**AMENDMENT - INVITATION TO TENDER**

<b>Title-Sujet:</b> Construction – Wabasca-Desmarais Detachment	
<b>Solicitation No. - No. de l'invitation</b> 201804138	<b>Date</b> Feb. 1st, 2018
<b>Client Reference No. - No. De Référence du Client</b> 201804138	<b>Amend No.- No. du modif.</b> 007
<b>GETS Reference No. - No. de Référence de SEAG</b> 201804138	
<b>Solicitation Closes –L'invitation prend fin</b>  <b>at - à</b> 16 :00 ET <b>on - le</b> Feb. 6th, 2018	
<b>F.O.B. - F.A.B.</b> Destination	
<b>Address Enquiries to: - Adresser toutes questions à:</b>  <a href="mailto:jordan.mckenna@rcmp-grc.gc.ca">jordan.mckenna@rcmp-grc.gc.ca</a>	
<b>Telephone No. - No de telephone</b> 613.843.5518	<b>Fax No. - N° de FAX:</b>
<b>Destination of Goods, Services, and Construction: Destinations des biens, services et construction:</b>	
<b>Delivery Required - Livraison exigée:</b>	<b>Delivery Offered - Livraison proposée</b>
<b>Name and title of person authorized to sign on behalf of Vendor/Firm Nom et titre de la personne autorisée à signer au nom du fournisseur/de l'entrepreneur</b>

**ADDENDUM No. 05**

**GOVERNMENT OF CANADA  
WABASCA-DESMARAIS GOVERNMENT BUILDING**

.3 Refer to DOMESTIC WATER HEATER SCHEDULE

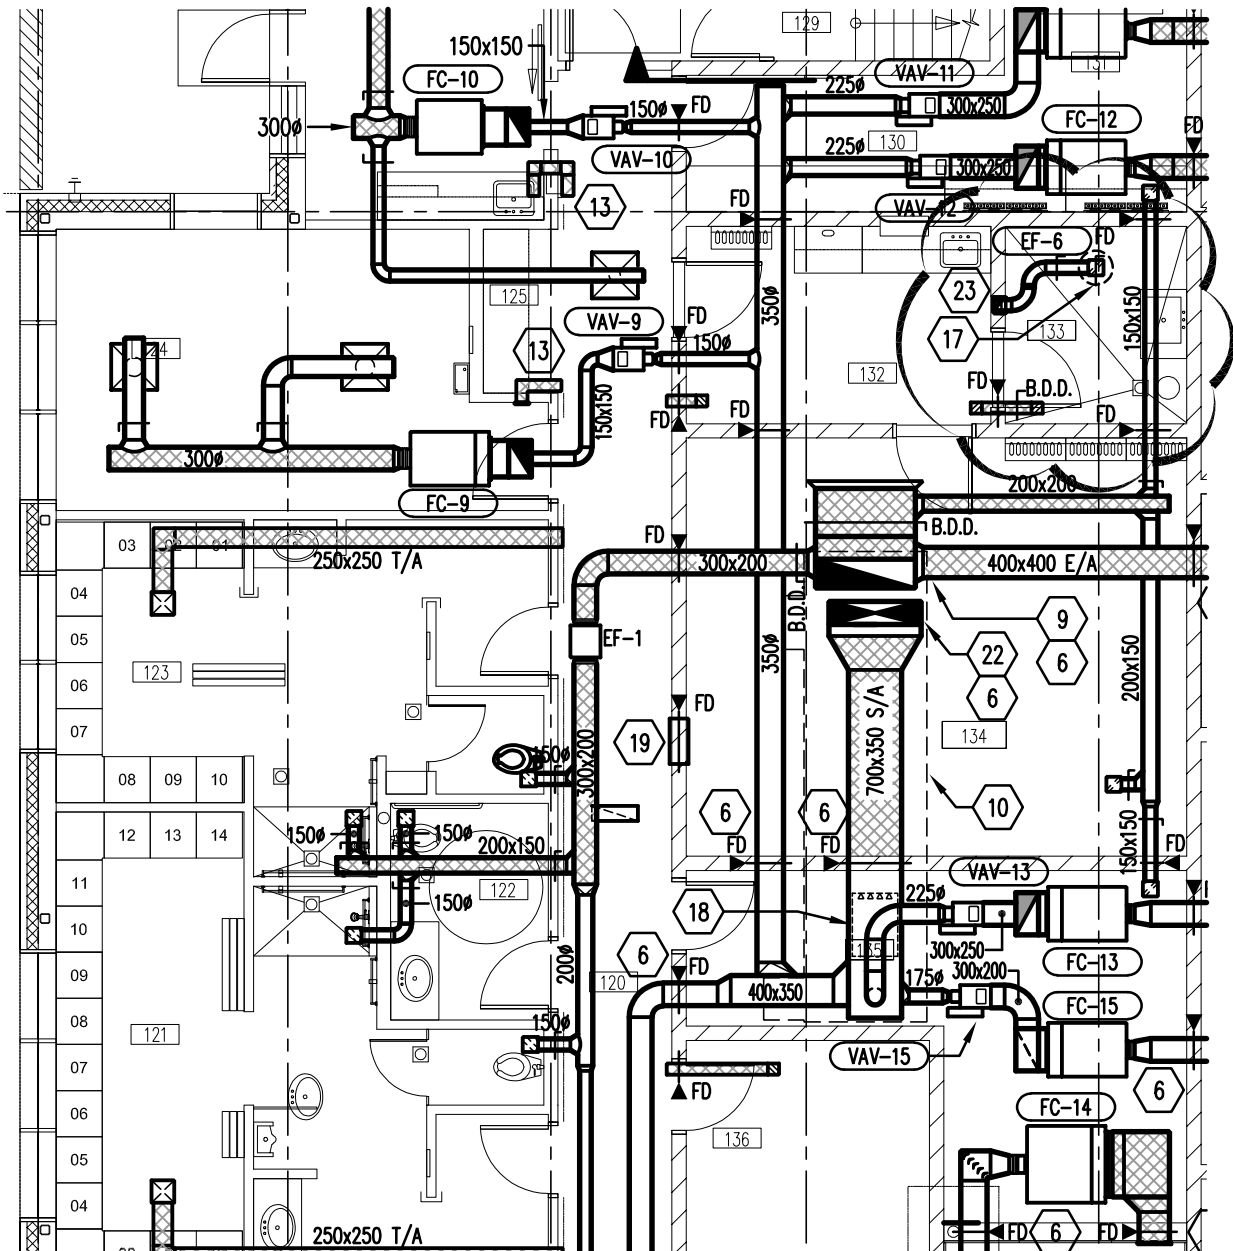
**ADD:** Add note to provide condensate neutralization kit for DWH-1 and DWH-2.

**M4.0-MSK-01**

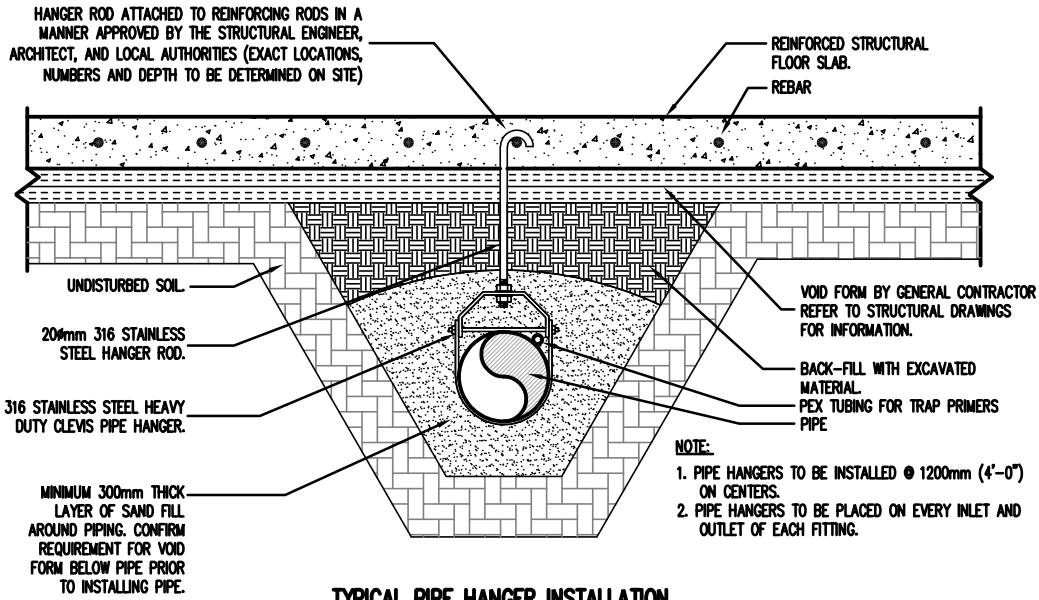
**REVISE:** Revise Room 13 exhaust layout and Keynotes 17 and 23 as per attached sketch M4.0-MSK-01.

**STRUCTURAL SLAB UNDERGROUND  
PIPE SUPPORT DETAIL  
(ADDENDUM M2)**

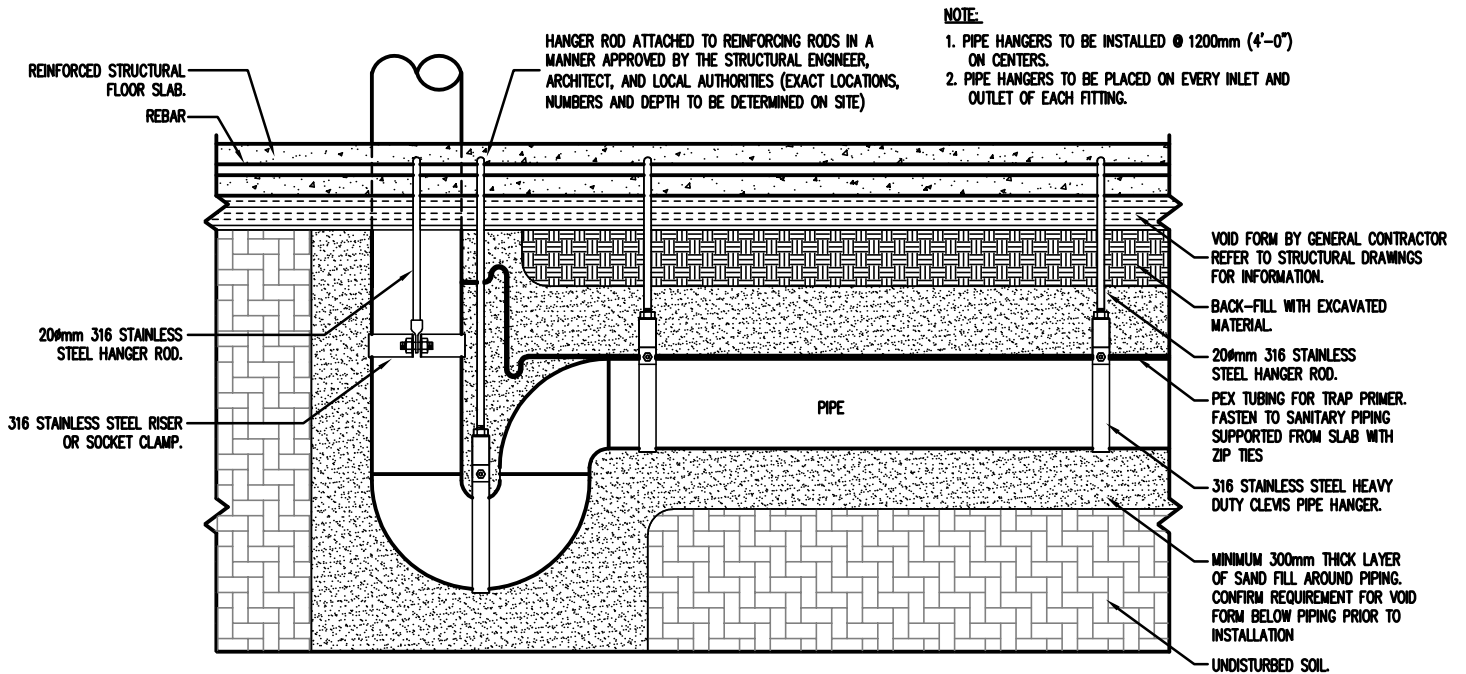
**ADD:** Add below slab pipe support detail as per attached.

2 CAR PEDESTAL RECEPTACLE DETAIL  
SCALE: NTS

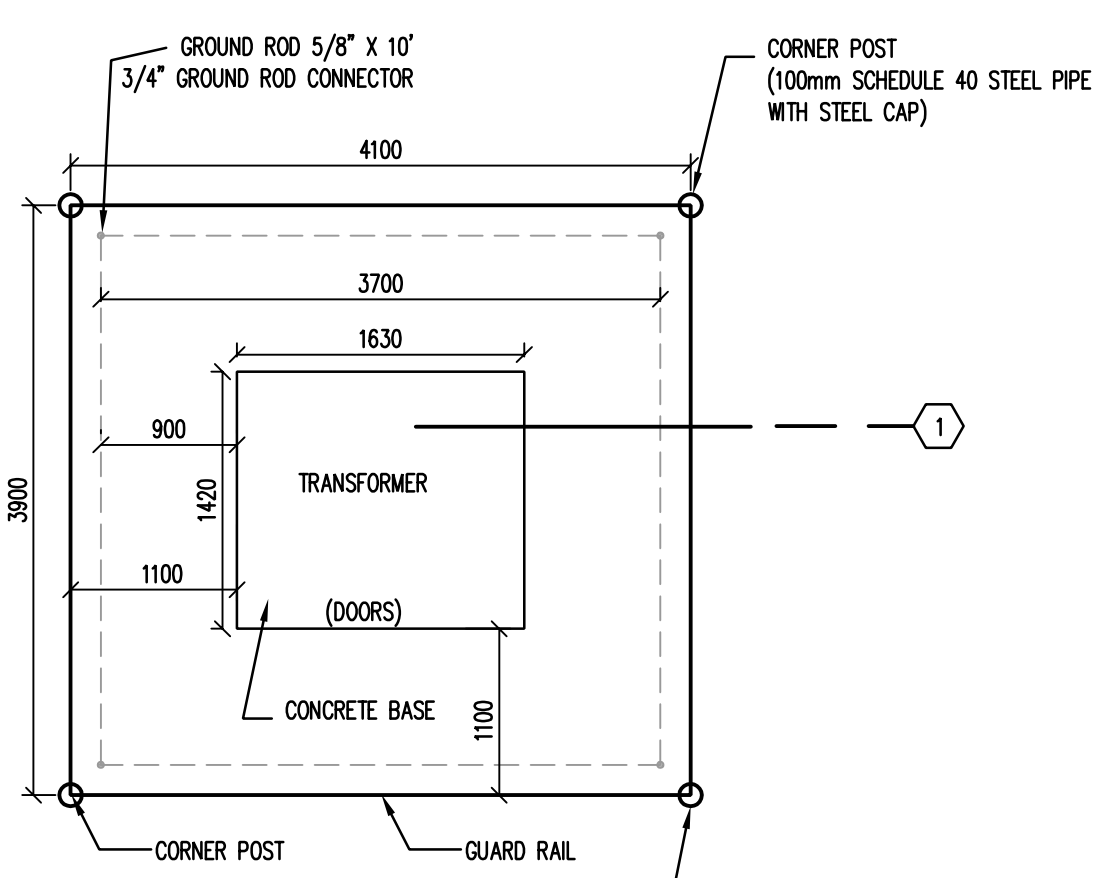
**REVISE:** Detail 2: Revise the note. The duplex receptacle is only on a single side as per the site plan layout. Remove the (ON EACH SIDE, FRONT & BACK).

**E2.0**

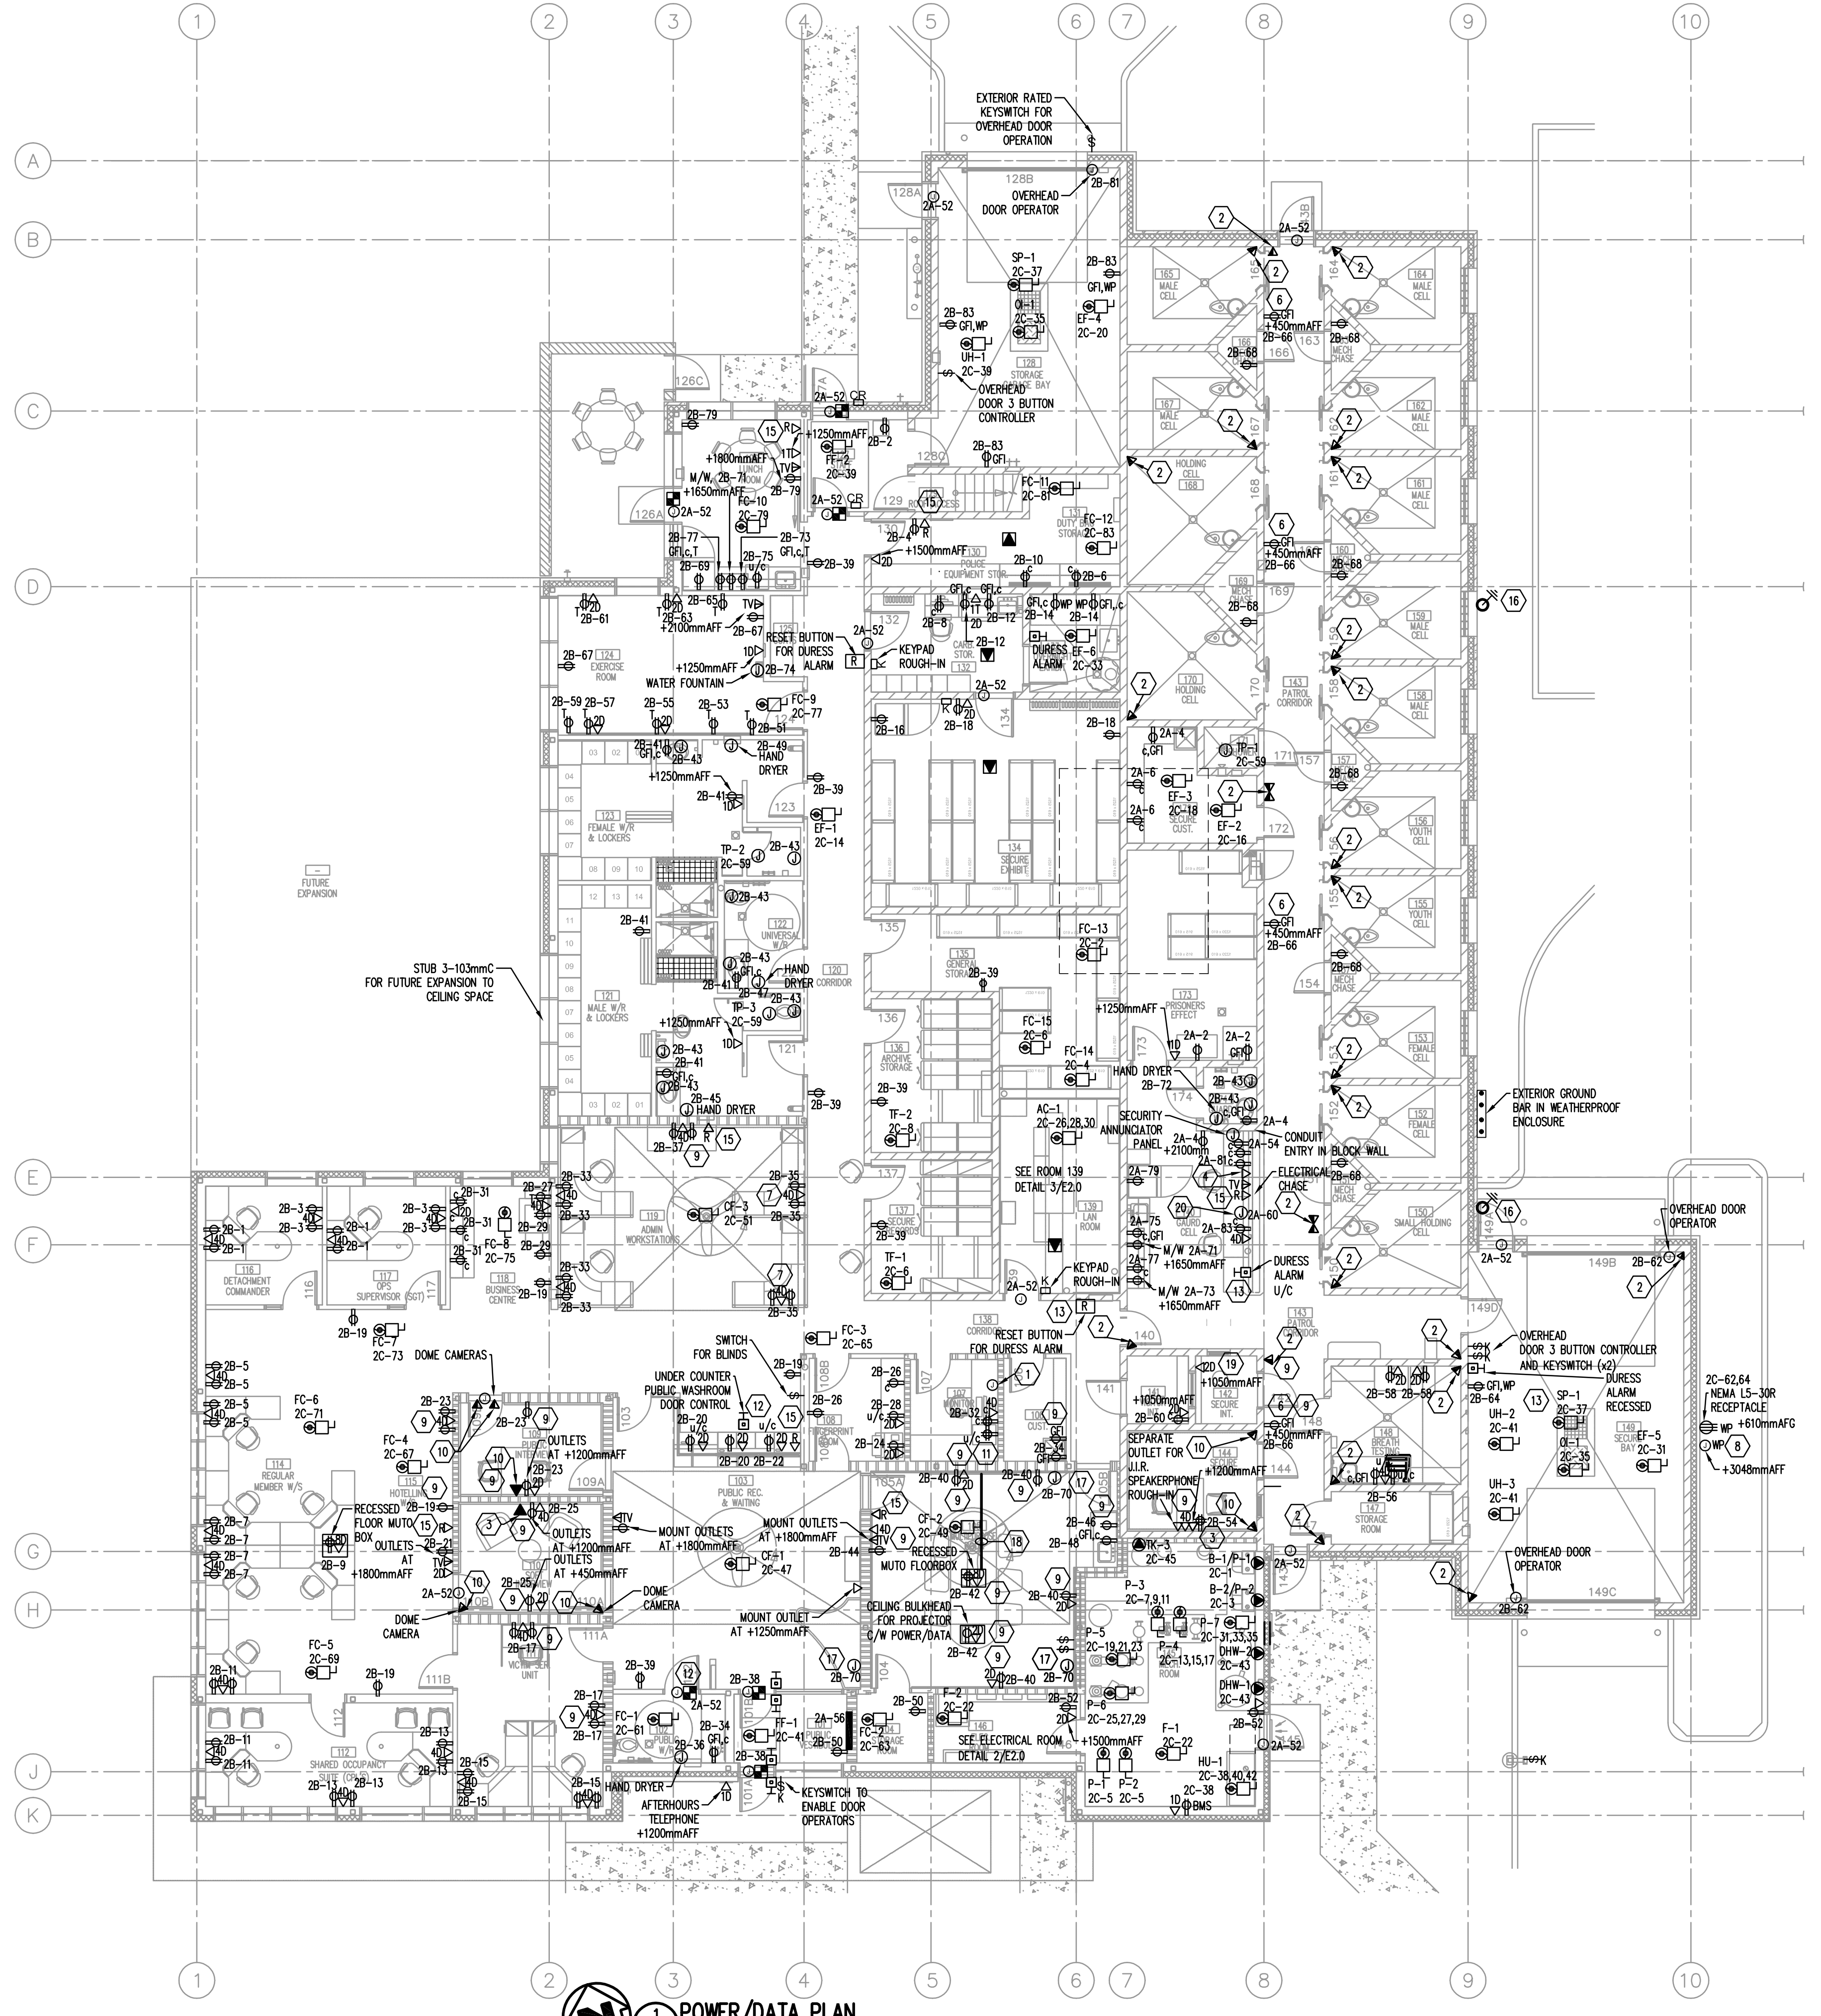
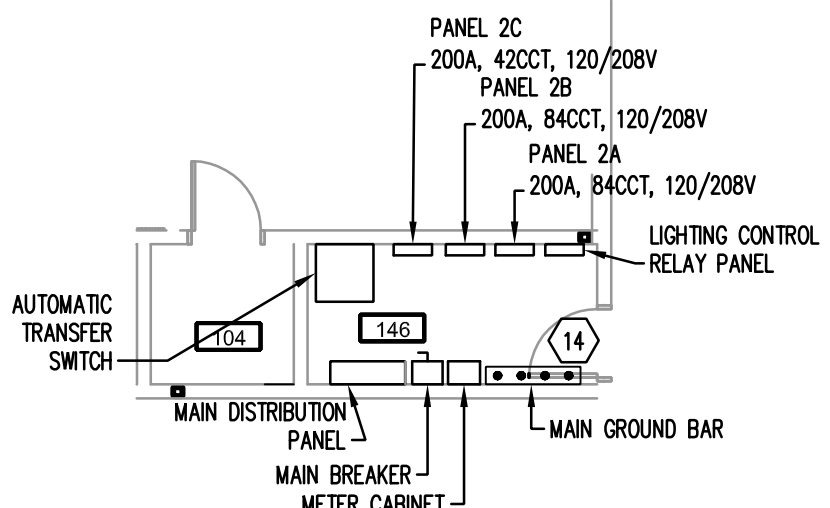
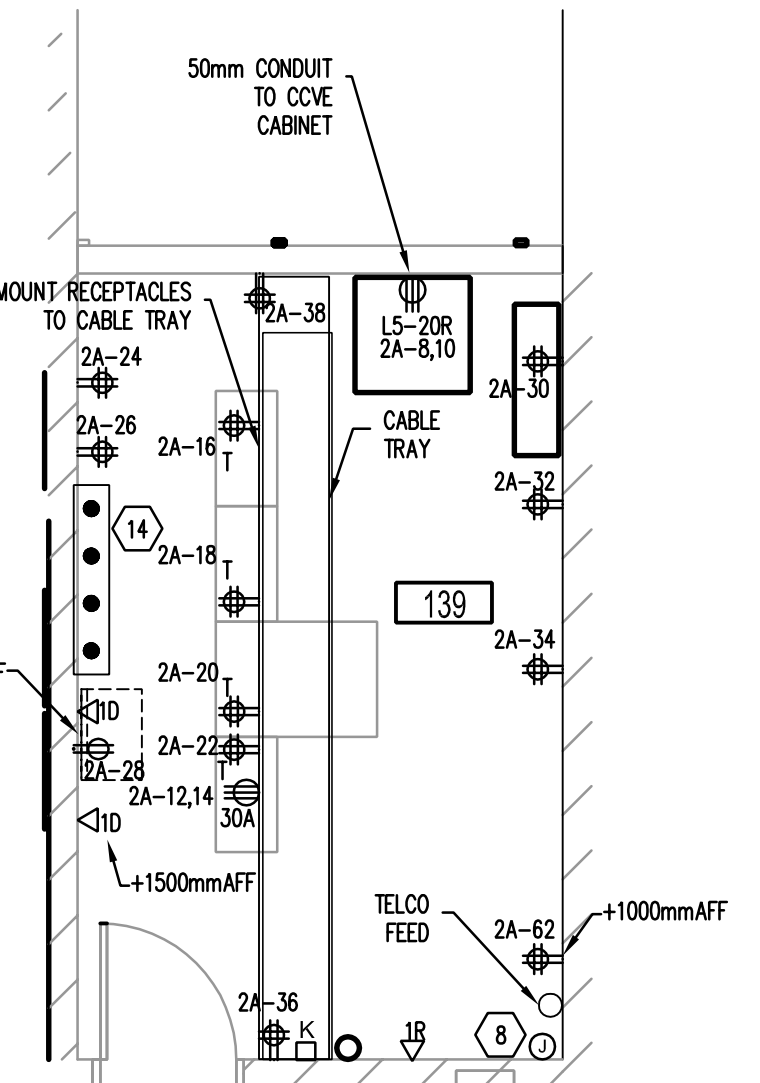
**REVISE:** Drawing has been re-issued with this addendum to address coordination with the architectural base plans and to reflect some minor additions. Changes include the addition of overhead door operator & switch outside 128; changes to room 133; added dome cameras to room 111 & 112; and selected minor power & data additions.
